Jackson Unit #3

API 30-025-33238 Lea County, NM

Plug and Abandonment Wolfcamp Perfs Aug 20, 2022

CONDITIONS OF APPROVAL FOR PLUGGING AND ABANDONMENT OCD - Southern District

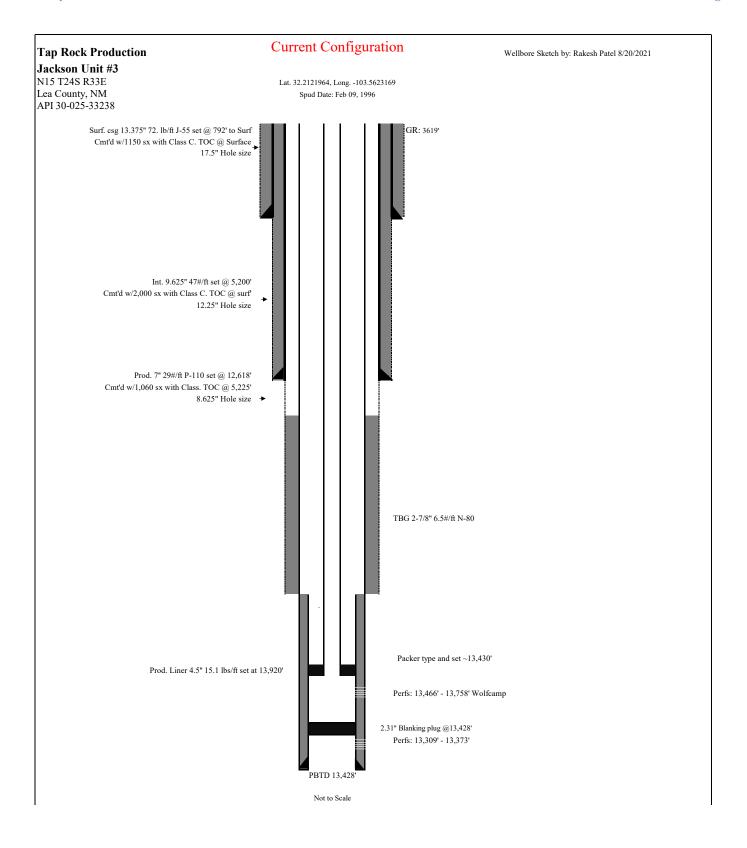
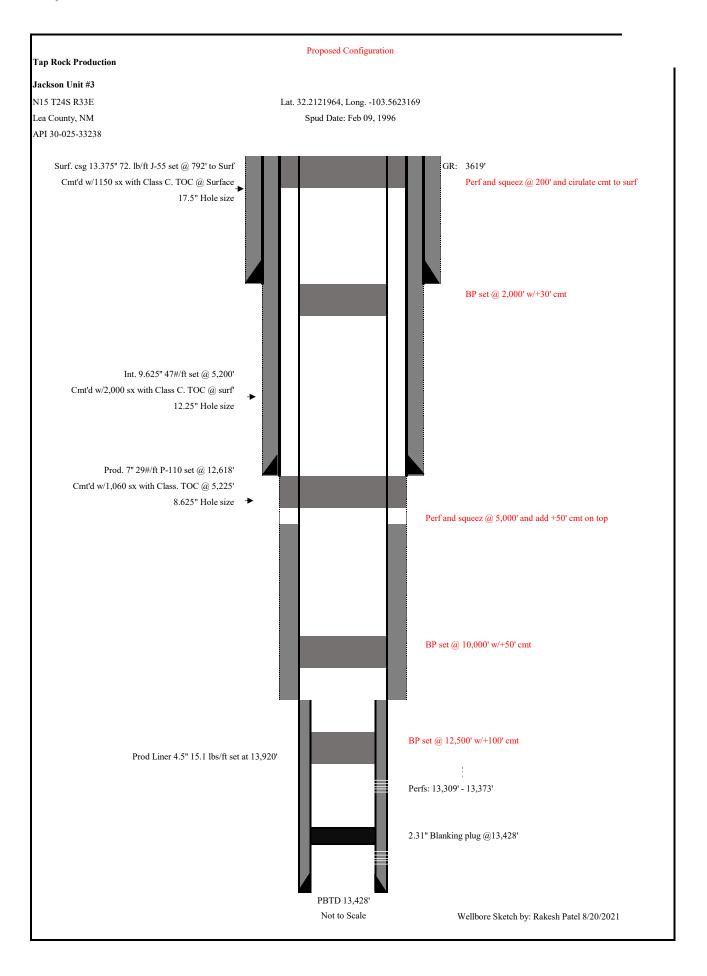
-		
		See at	ttached conditions of	approva
4" Diameter 4' tall abov	e ground marker			
	NOTE CHANGES TO PL	DOCEDIDE		
	NOTE CHANGES TO TH	ROCEDURE		
			11.11.0	
I hereby certify that the informati	on above is true and complete to the l	oest of my knowledge	e and belief.	
SIGNATURE	TITLE Regula	atory Analyst	DATE 8/25/2022	
				910
Type or print name	E-mail addres	ss: jtrlica@taprk.com	PHONE:

13,200 100' above top perf

- Plug #1. RIH w/BP setting at ~12,500. Mix and pump 100 sacks of Class G cement on top spotting a balanced plug inside casing to isolate the interval. PUH. WOC. Tag and record final top depth of cement. Spot 50 sx 12,000 WOC & Tag
- Plug #2. PUH and set BP at ~10,000'. Mix and pump 50 sacks of Class G cement on top Spot 50 sx 7490 spotting a balanced plug inside casing to isolate the interval. PUH. WOC. Tag

5250 50' below CSG shoe

WOC & Tag
- Plug #3. PTOOH and MIRU wireline, perforate 7" casing ~5000. RD wireline and TIH with tbg and set cement plug at ~4,950', follow by pumping minimum 50 sacks of cement thru perfs squeezing casing and annulus. PUH. WOC. Tag and record final top of cement.
- Plug #4. PUH and set BP at ~2,000'. Mix and pump 30 sacks of Class G cement on top spotting a balanced plug inside casing to isolate the interval. PUH. WOC. Tag and record final top depth of cement. Spot 50 sx 1267 Salt sec P&S 50 Sx 800' Csg shoe

Created By	Condition	Condition Date
kfortner	See attached COA Note changes to procedure	9/14/2022
